2. 1199 West Central Street

Re: 1199 West Central Street – Garelick Farms
MassDEP File No. 159-1322
Notice of Intent Peer Review #2

FRANKLIN, MA
GARELICK FARMS
FLOODING RESILIENCY IMPROVEMENTS
PERMIT DRAWINGS
SEPTEMBER 2025
REVISED OCTOBER 2025
REVISED DECEMBER 2025
REVISED JANUARY 2026

G-003

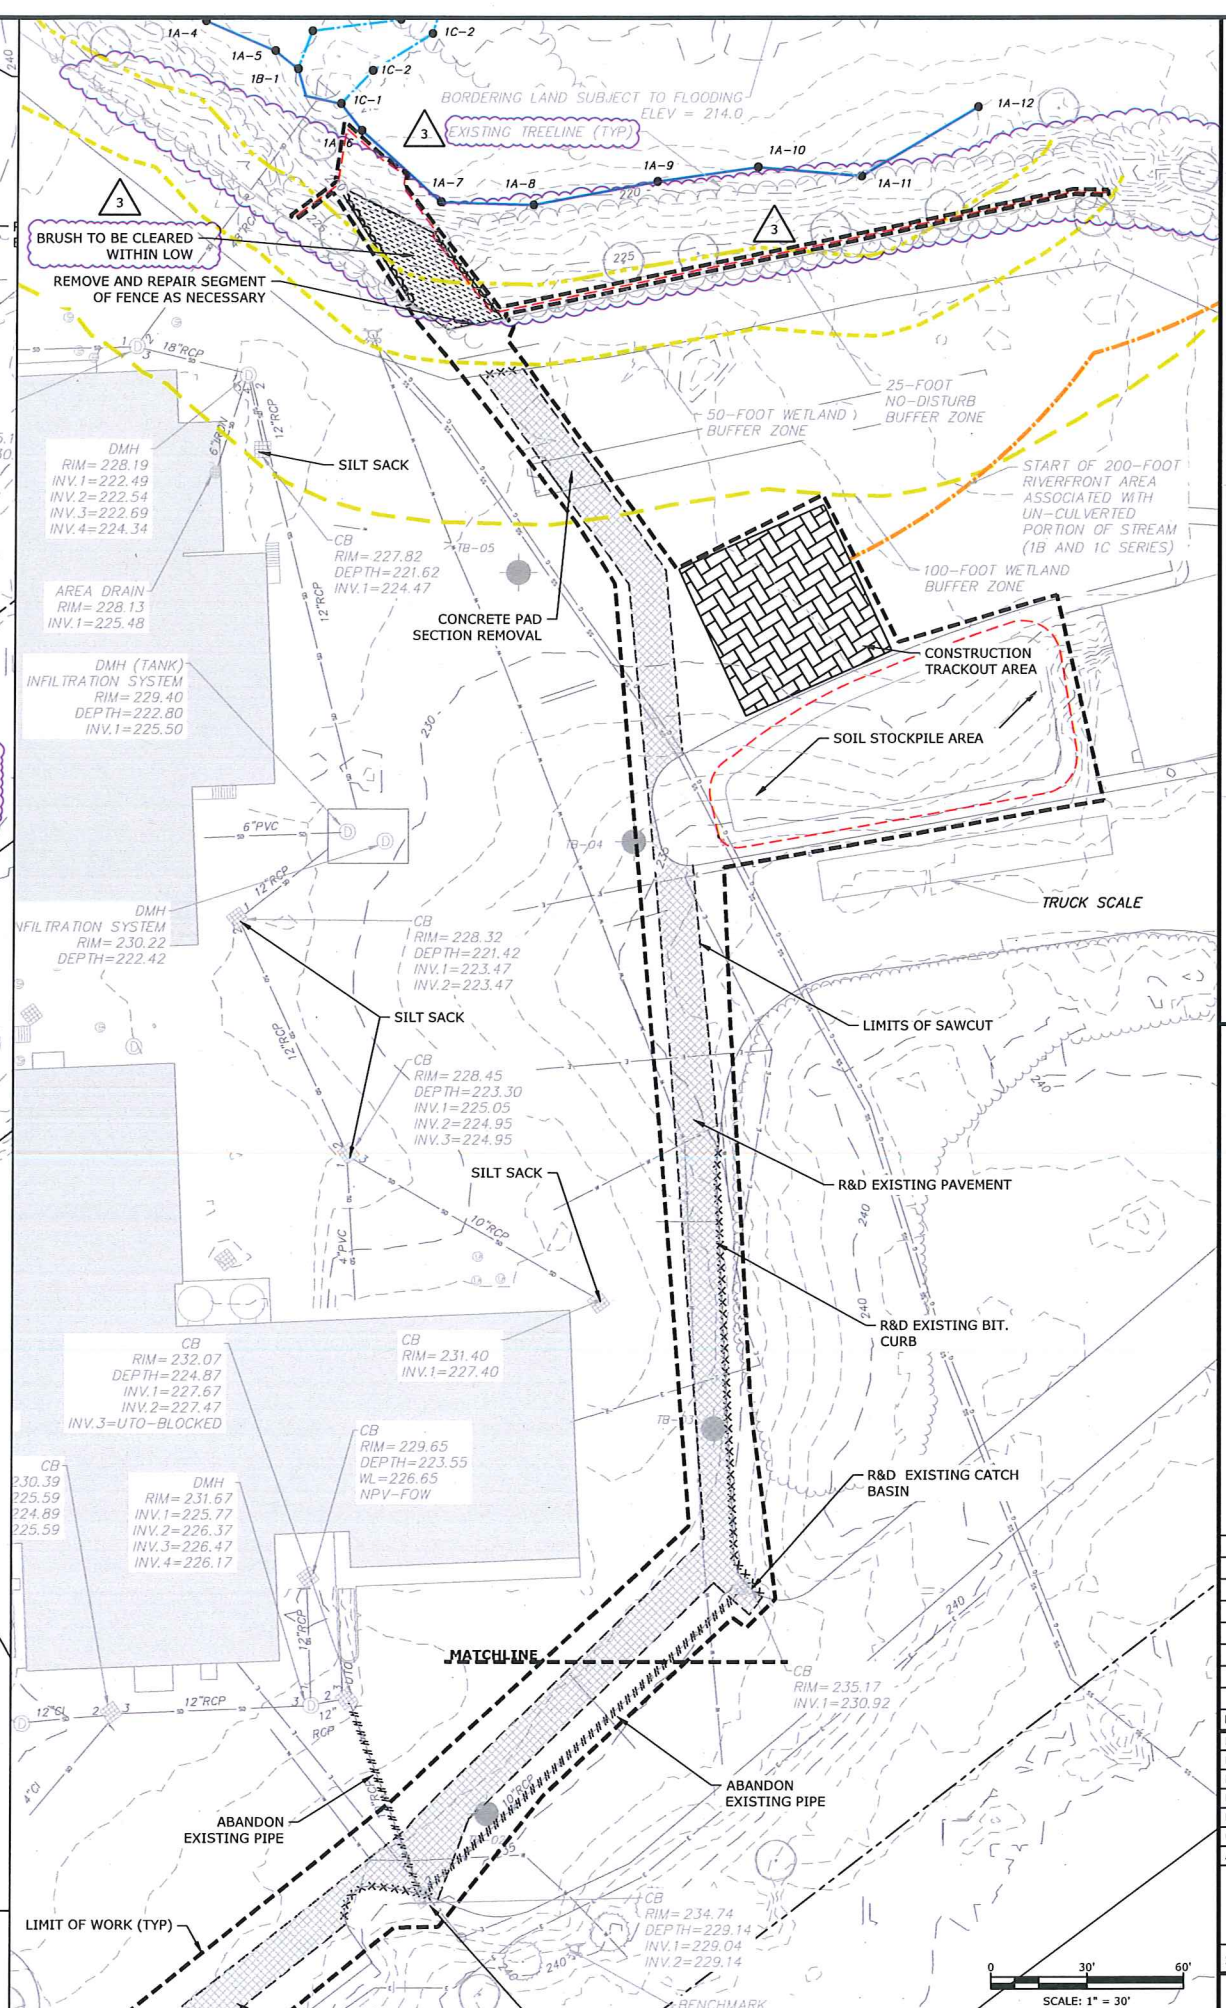
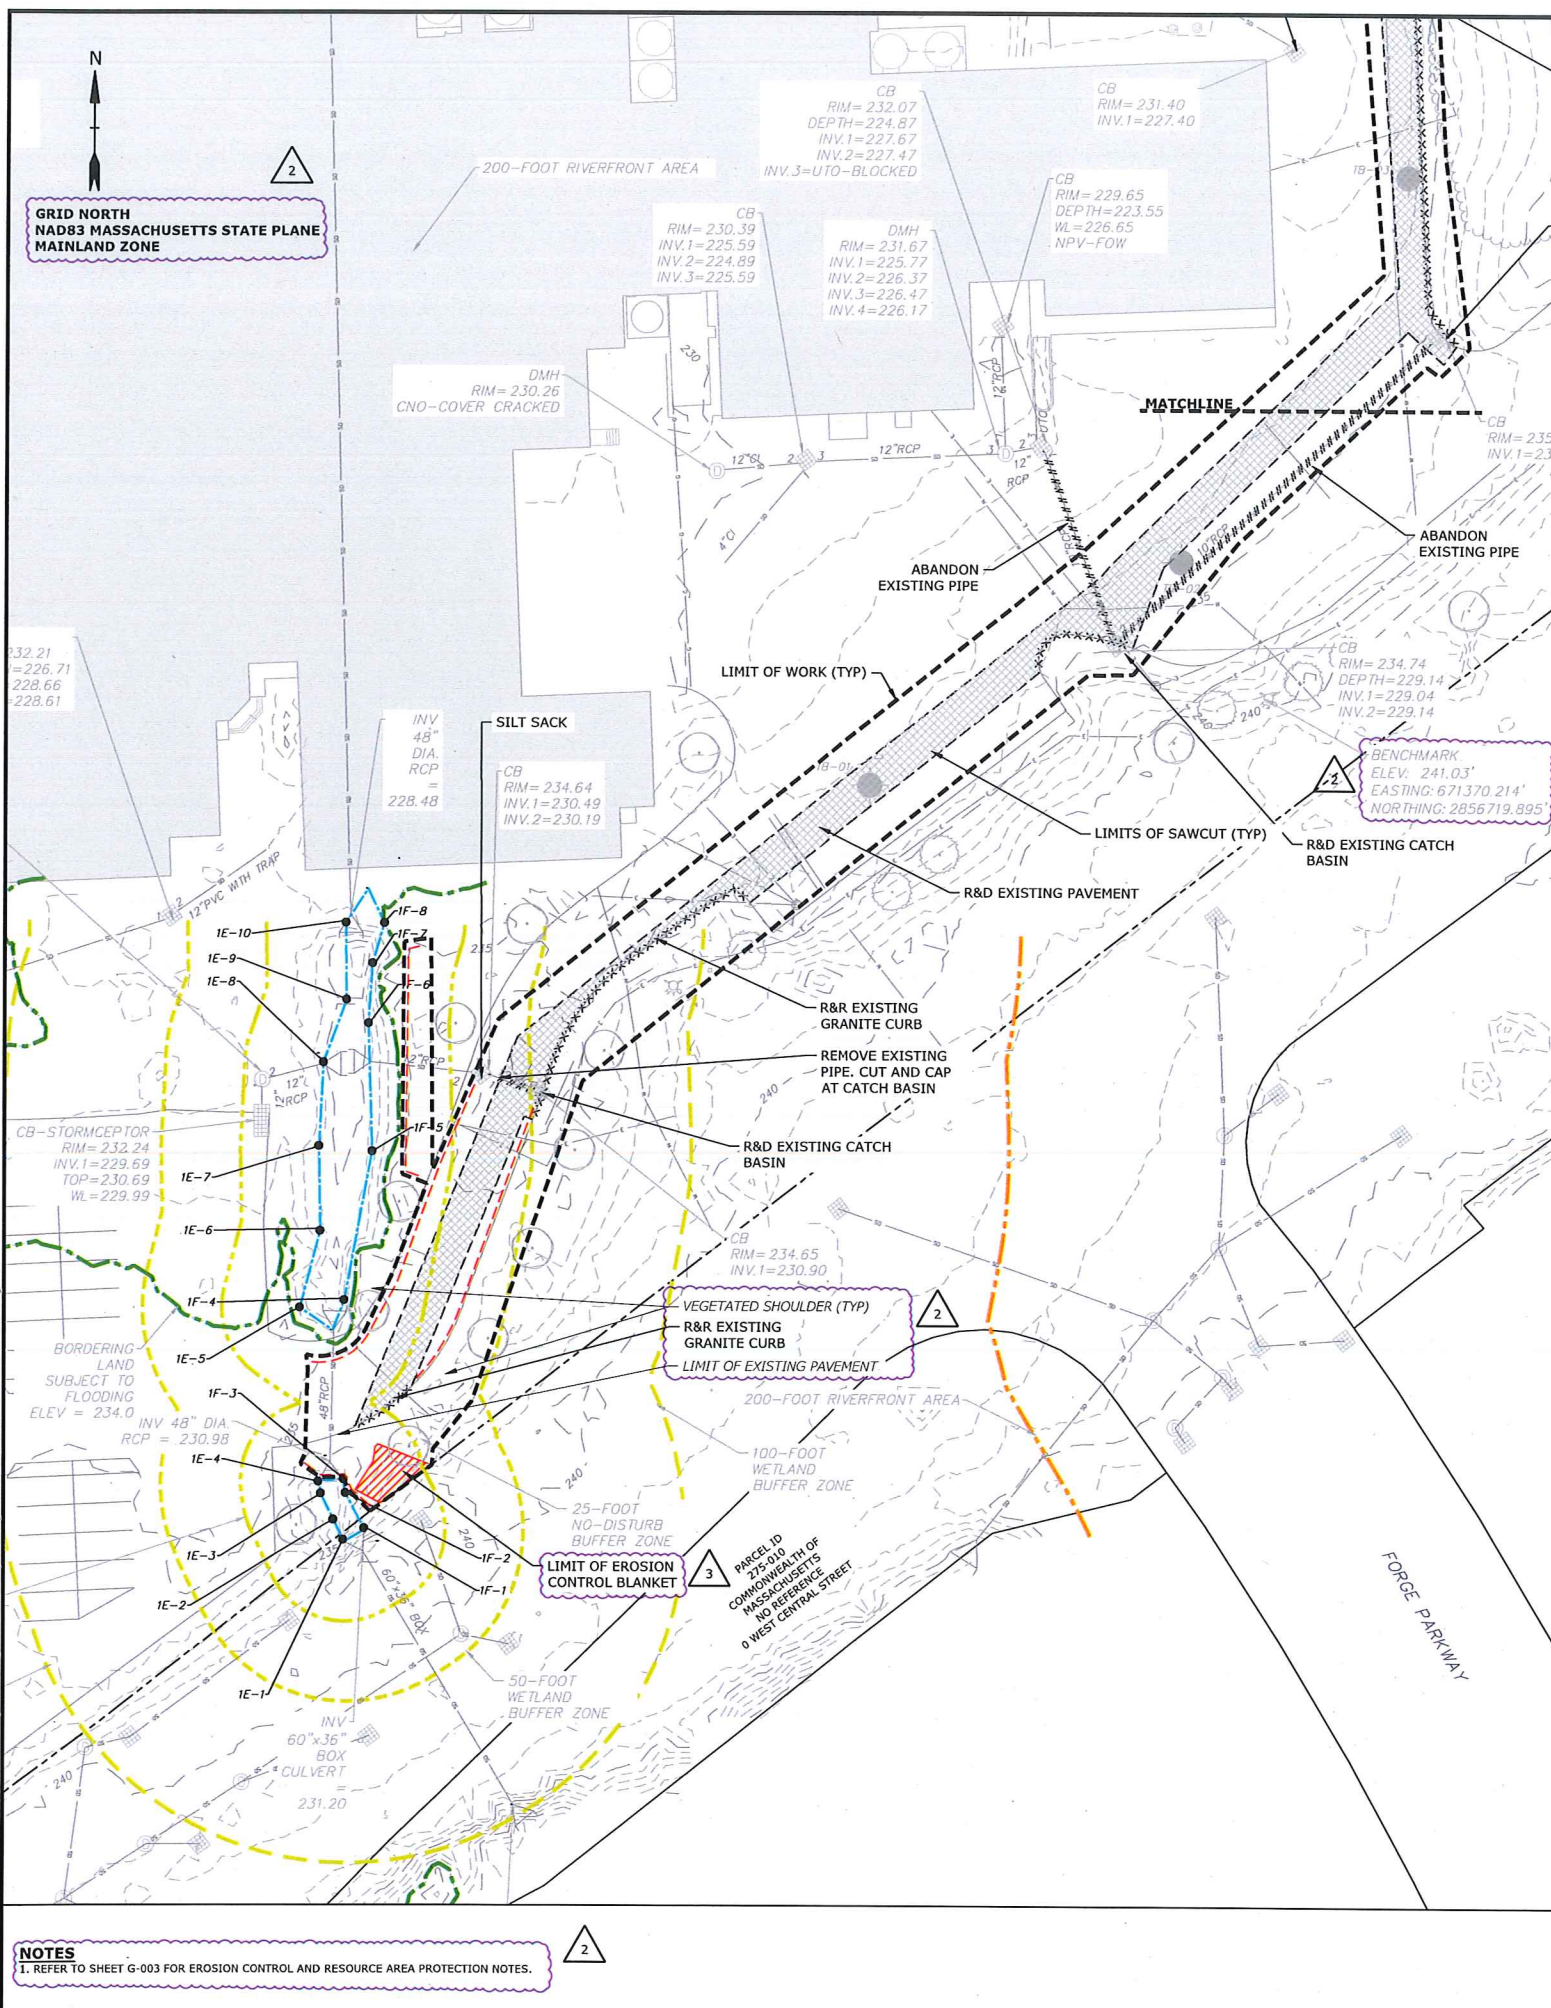
- c. A Construction Sequence with all proposed activities within Jurisdictional Areas should be provided on the plans per Bylaw Regulations Section 7.18.1.14.

- W16. The Applicant should provide the Construction Sequence on the plans per Bylaw Section 7.15.

TB: This information has been added to the plan set on sheet G-003.

TB: This information has been added to the plan set on sheet G-003.
